SUBJECT: PERRY NUCLEAR POWER PLANT, UNIT NO. 1 - ISSUANCE OF AMENDMENT
CONCERNING CHANGES TO PRESSURE TEMPERATURE CURVES (TAC NO.
MF4351)(L-14-150)

Amendment No. 168
License No. NPF-58

SAFETY EVALUATION BY THE OFFICE OF NUCLEAR REACTOR REGULATION
RELATED TO AMENDMENT NO. 168 TO FACILITY OPERATING LICENSE NO. NPF-58

FIGURE 3.4.11-1(a): PRESSURE TEST CURVES (VALID UP TO 32 EFPY)

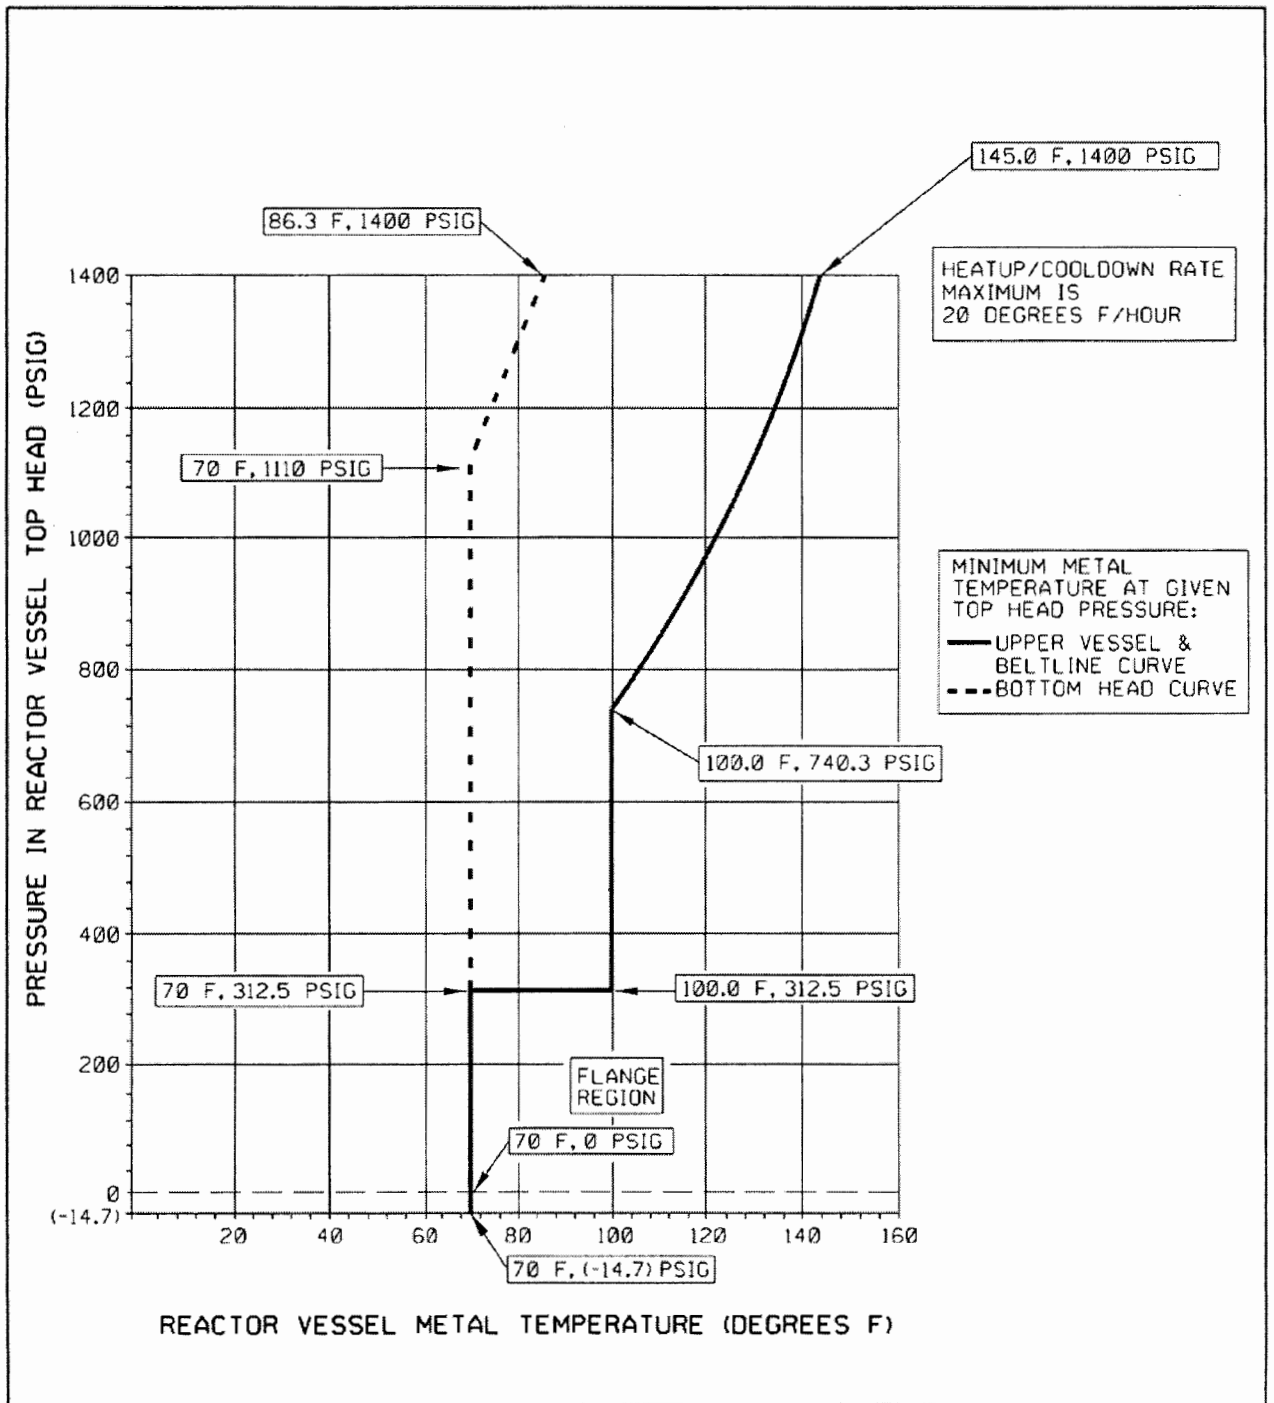
In the June 23, 2014 submittal indicates that the portion of the proposed P/T limits based on the WLIN curves was obtained from applying the TR methodology. As stated in Attachment 4 Section I, "Development of P/T Curves," the WLIN material is stainless steel and, therefore, does not require P/T limit evaluation. This is because the fracture toughness requirements of 10 CFR Part 50 Appendix G are only for ferritic materials of a RPV. However, the integrity of the adjacent shell with a cylindrical hole must still be evaluated in accordance with 10 CFR 50, Appendix G. The TR was developed in 2011 to address this relatively new issue, and the WLIN curves generated by the licensee are the results of applying the TR methodology,

Since the four WLINs lie in shell Ring # 2 (located at the top of active fuel, designated at N12), the licensee used the highest ART for all plates and welds in Ring # 2 (Table 1 of Section I of Attachment 4) to generate the WLIN curves. This approach is conservative and, therefore, acceptable. The selected ART value of 59 °F for the subsequent generation of the proposed WLIN curves is also acceptable because as the licensee indicated in the February 27, 2015, supplement, the ART value underlying the current TS 32 EFPYs P/T limits remains unchanged for the proposed P/T limits.

The licensee used the stress intensity factor due to 1000 psig of applied pressure ($K_{Ip-applied}$) and maximum K_{It} from the TR ($K_{Ip-applied} = 69.4 \text{ ksi}\sqrt{\text{in}}$; $K_{It} = 38.6 \text{ ksi}\sqrt{\text{in}}$) to generate the proposed P/T limits for WLINs. Attachment 4 reports at one place a lower $K_{Ip-applied}$ value. This discrepancy prompted the staff to question whether the assumptions for the TR methodology might not be completely followed. In the February 27, 2015, supplement, the licensee indicates that the lower K_{It} value is a typographical error. The NRC staff performed independent calculations using these $K_{Ip-applied}$ and K_{It} values and the ART value for the limiting shell plate in Ring # 2 to validate the licensee's WLIN curves and found that for a given pressure along the WLIN curve in Attachments 2, 4, or 6 of the attachment for various operating conditions, the difference between the NRC staff's calculated temperature and the licensee's temperature is within 2 percent. Therefore, the staff determined that the licensee has applied the TR methodology for WLINs adequately.

[t]he minimum temperature of the leak test needs to be increased to satisfy the impact of the WLIN Leak Test curve at 32 EFPY, Attachment 2.

Appendix G to 10 CFR 50 contains additional requirements for the minimum metal temperature of the closure head flange and vessel flange regions. These considerations were reflected in the “notches” of the P/T limits. The NRC staff has verified that when $P > 20$ percent of the hydro test pressure (~ 313 psig), the minimum temperature of 100 °F for the pressure test curve, 130 °F for the normal operation/core not critical curve, and 170 °F for the normal operation/core critical curve are derived from adding the RT_{NDT} of 10 °F for the limiting flange material temperature to 90 °F, 120 °F, and 160 °F that were specified in 10 CFR Part 50, Appendix G for the three operating conditions. The RT_{NDT} of 10 °F for the limiting flange material temperature was not reported in the June 23, 2014, submittal. However, it is reported in the June 4, 2002, submittal for the current P/T limits. As discussed above, the initial RT_{NDT} value for the closure flange remains valid. Instead RT_{NDT} was determined in accordance with the ASME Code, Section III, NB-2331, using test data from transverse Charpy specimens. The NRC staff has also verified that when $P \leq 313$ psig, the minimum temperature of 70 °F (10 °F + 60 °F) for the pressure test curve and the normal operation/core not critical curve is also determined in accordance with the limiting flange material temperature that was specified in 10 CFR 50, Appendix G.

The NRC staff performed independent evaluations and verified that the P/T limits were developed appropriately using the approved methodologies, and the proposed P/T limits valid for 32 EFPYs satisfy the requirements of Appendix G to Section XI of the ASME Code and Appendix G to 10 CFR Part 50. Therefore, based on the proposed RPV P/T limits being sufficiently bounding for the identified materials and having used an approved methodology as documented in GE-NE-0000-0000-8763-01, Revision 0, and BWROG-TP-11-023-A, Revision 0, the NRC staff finds the revisions to the P/T curves in TS Figures 3.4.11-1(d) – 3.4.11-1(f) acceptable.

In Section 2.0 of the June 23, 2014, submittal, the licensee describes various changes to text elements of current TS Figures 3.4.11-1(d) – 3.4.11-1(f). The NRC staff reviewed the proposed revisions to the identified TS Figures and determined that the changes provide greater parity with the intent of the curves as discussed in Attachment 4 to the June 23, 2014, submittal. As the proposed changes to text elements on the TS figures reflect the technical discussions reviewed above and do not materially alter the TS requirements, the NRC staff finds the revisions to current TS Figures 3.4.11-1(d) – 3.4.11-1(f) acceptable.

FIGURE 3.4.11-1(b): NON-NUCLEAR HEATUP/COOLDOWN CURVES (VALID UP TO 32 EFPY)

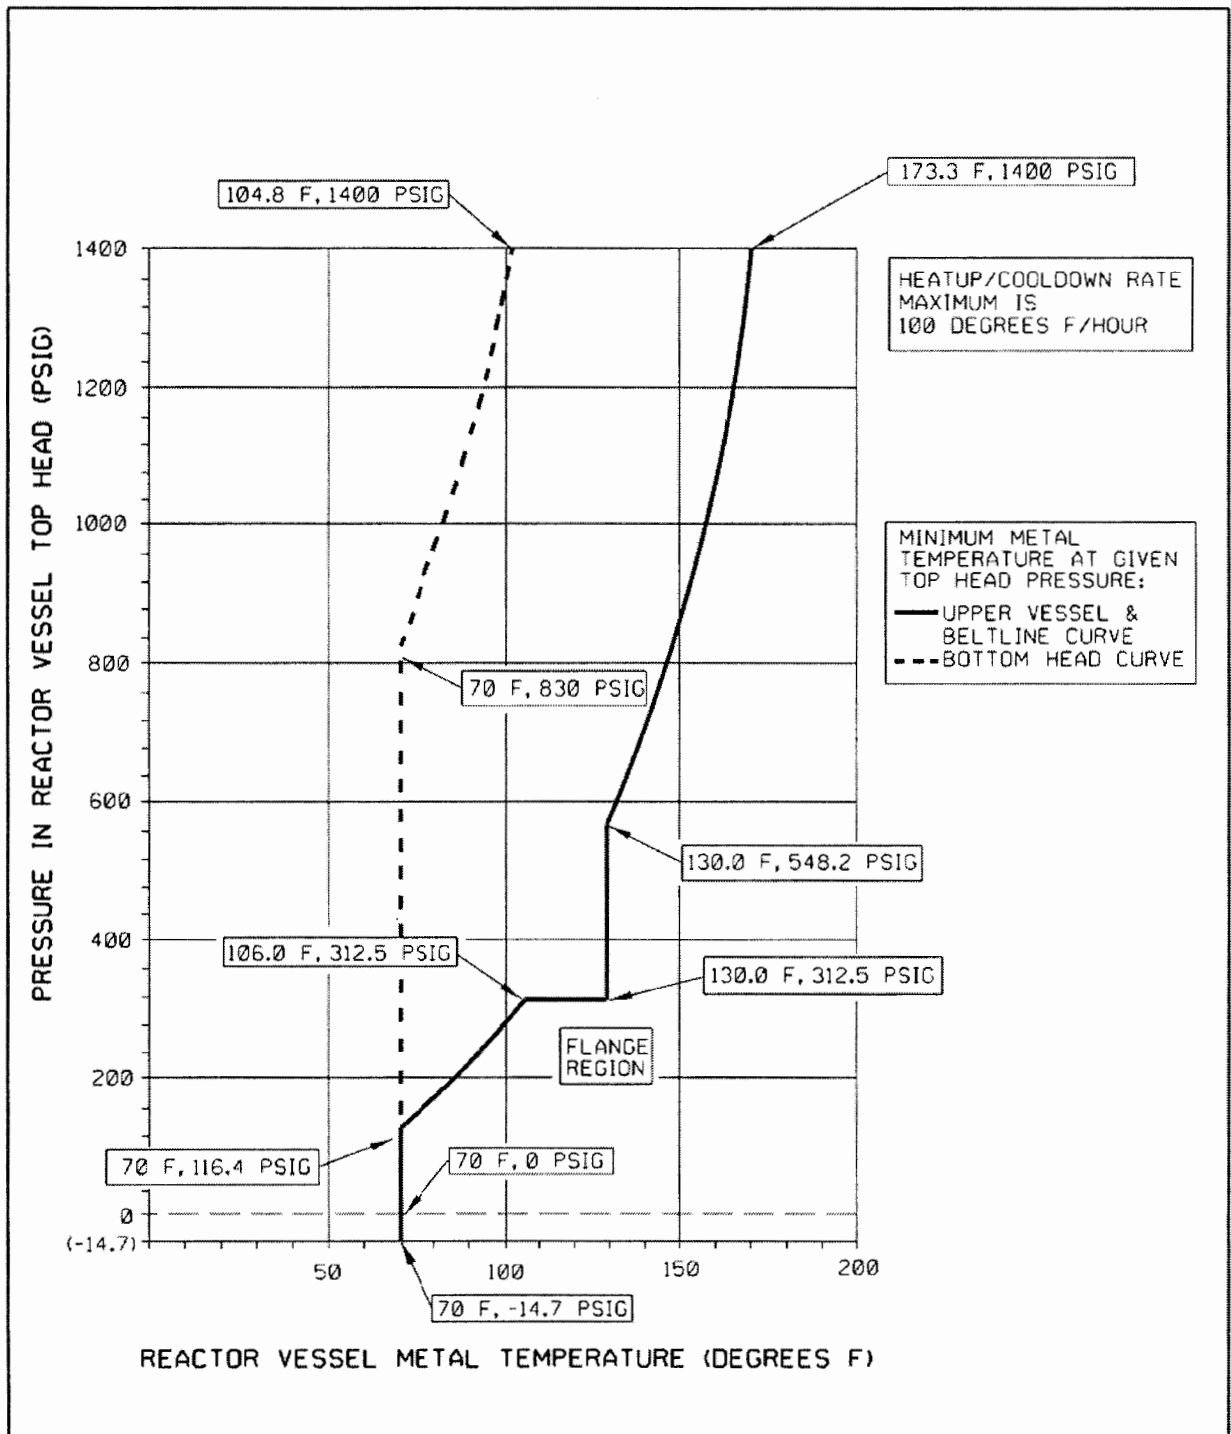
The NRC staff was concerned that inclusion of vessel static head might not be applied to all proposed P/T limits. The licensee in the supplement clarified that the bottom head curves already considered vessel static head, but did not mention the upper vessel and beltline curves. The NRC staff identified, in the current TS 32 EFPYs P/T limits in Attachment 1 to the June 23, 2014, submittal, "Proposed Technical Specification Changes (MARK-UP)," that the horizontal segment of the upper vessel and beltline curves indicate a pressure of 312.5 pounds per square inch gage (psig), which is the calculated pressure of 343.3 psig minus the vessel static head of 30.8 psig. This indicated that, like the current TS 32 EFPYs bottom head curves, the current TS 32 EFPYs upper vessel and beltline curves have also considered the vessel static head.
